Disability Access Report

Proposed Residential Development Lot 1 DP 204077 11-17 Mosbri Crescent THE HILL NSW

Ref: LP\_18187

Figure 2 | Overall Site Plan

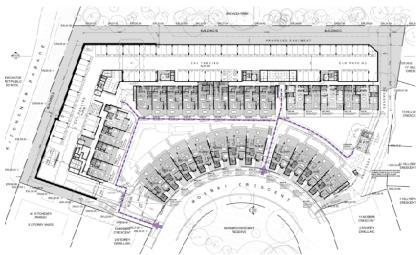
A pedestrian link from the Mosbri Crescent footpath to each of the apartment building entrances is provided. Levels provided show that the pedestrian link is conducive to the provision of an accessible path of travel within the meaning of AS1428.

For the townhouses, while stair access is provided to select townhouses from Mosbri Crescent, a path of travel is achievable to each townhouse via the rear landscaped areas. There will be an optional purchase upgrade for a lift that facilitates access between the carparking area and individual townhouses.
